Subject: FW: Historic Preservation Commission Meeting October 7, 2026

EUREKA WOMAN'S
CLUB KITCHEN
REMODEL

EXTERIOR
ELEVATIONS &
DETAILS

A3.1

1 Section 2
3/4" = 1'-0"

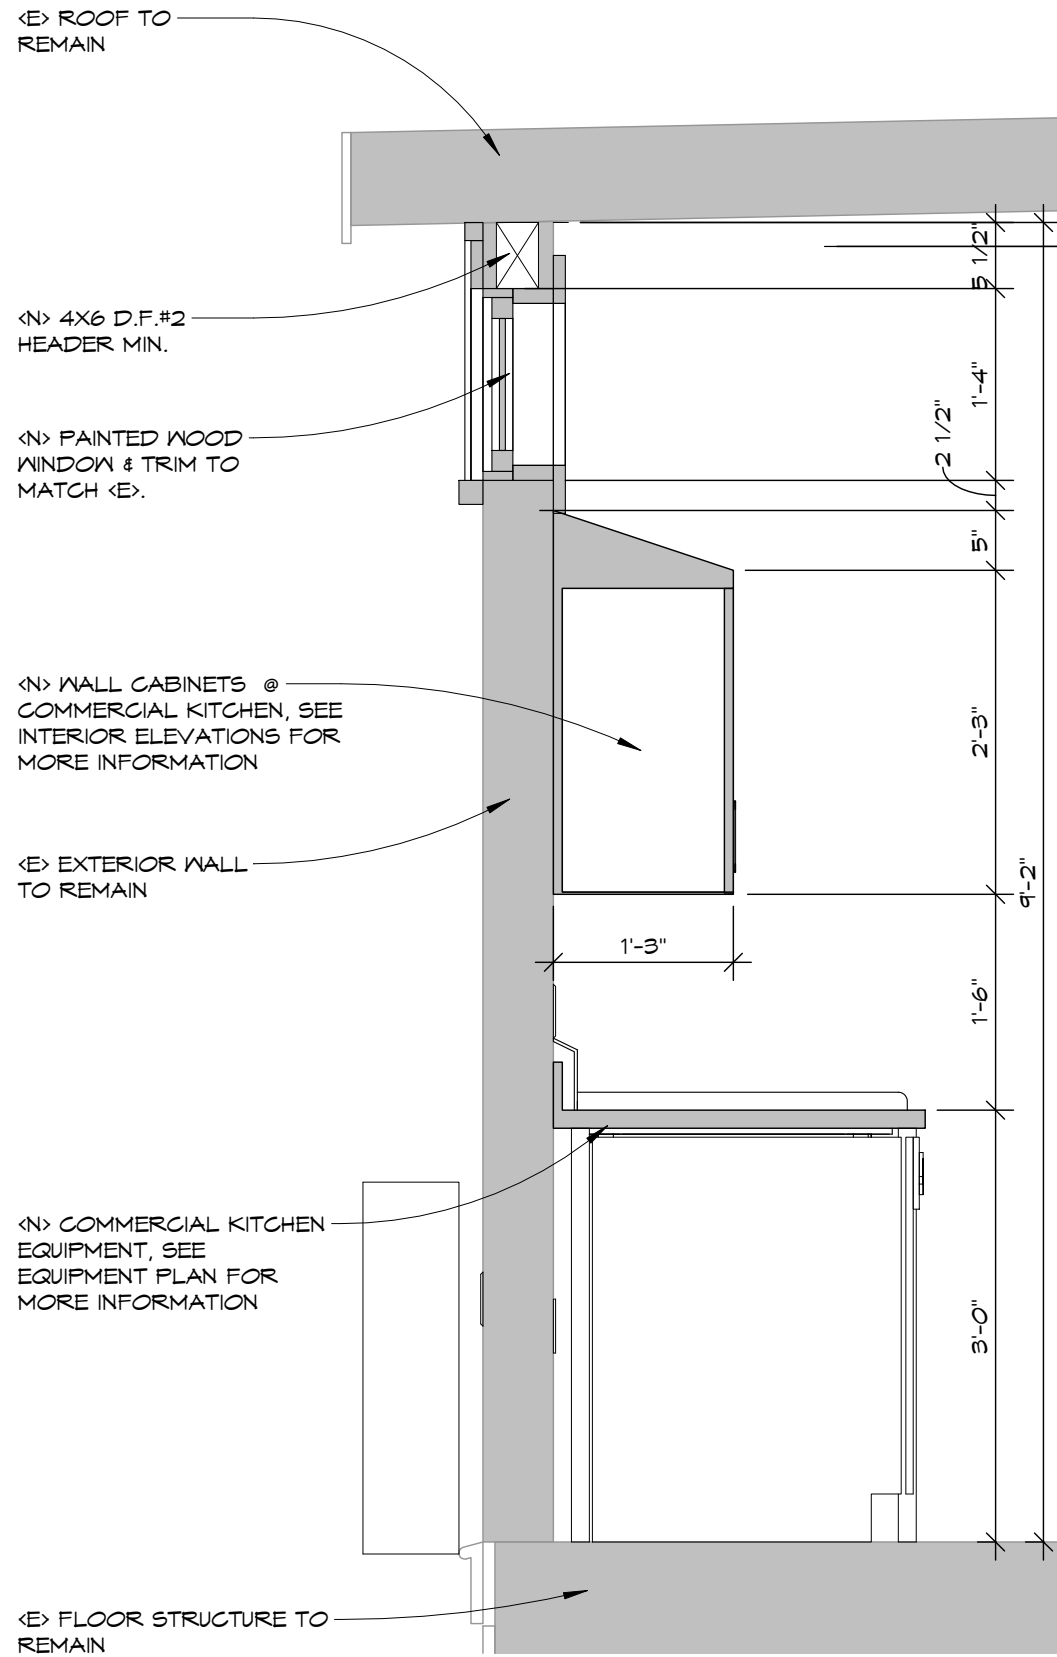
Through the bidding process, the decision has been made to change the new windows to fixed in order to avoid complications with screens and operable hardware. Since the windows will be painted we are giving the contractors the option between straight grain fir and redwood as the existing building has both types of wood windows. The new glazing inserts will be insulated dual pane.
